CITY OF ALBUQUERQUE

**RE: Lot 4, Block 8, Unit 22 Volcano Cliffs
6416 Canavio Pl NW
Grading and Drainage Plan
Engineers Stamp Date 5/5/15 (D10D003E4)**

DRAINAGE AND TRANSPORTATION INFORMATION SHEET

GRADING & DRAINAGE PLAN
6416 Canavio Place NW
LOTS 4, BLOCK 8, UNIT 22 VCS

GRADING AND DRAINAGE PLAN
LOT 4 , BLOCK 8 , UNIT 22 , VCS
ADDRESS: 6416 Canavio PL NW

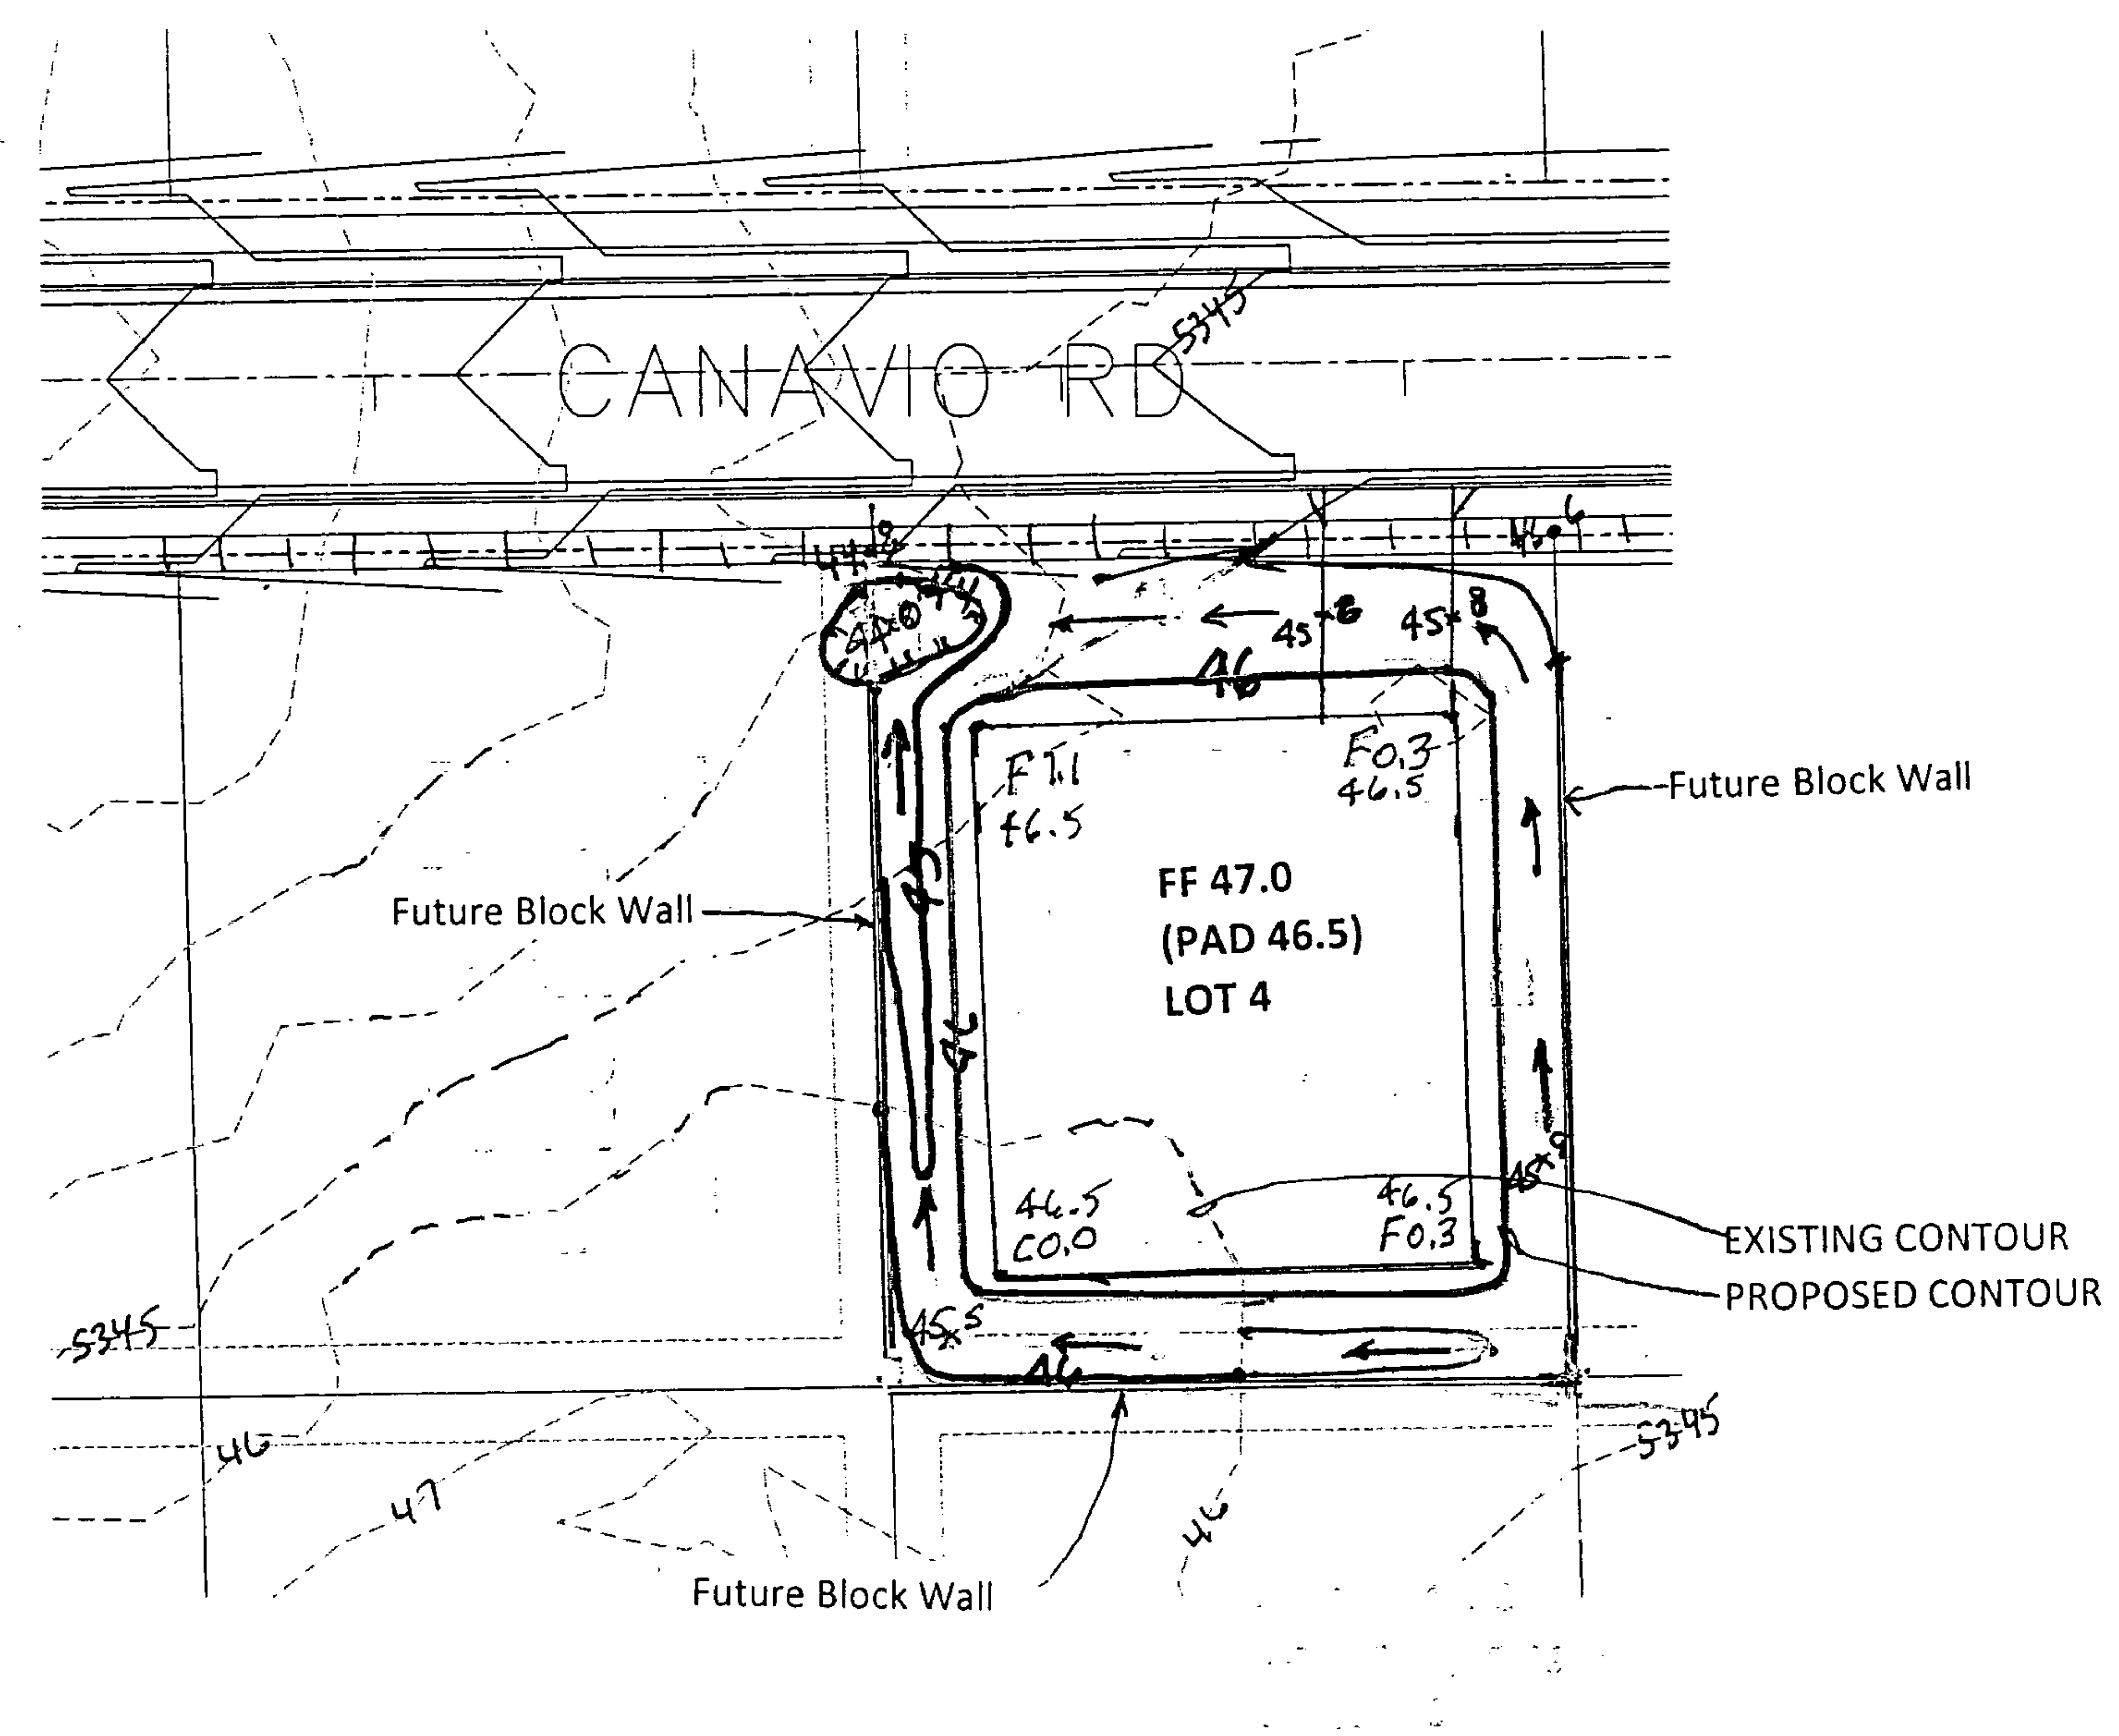
Based upon the information provided in your submittal received 5/5/2015, this plan is approved for Grading Permit and Building Permit.

Please attach a copy of this approved plan to the construction sets in the permitting process prior to sign-off by Hydrology.

Prior to Certificate of Occupancy release, Engineer Certification per the DPM checklist will be required.
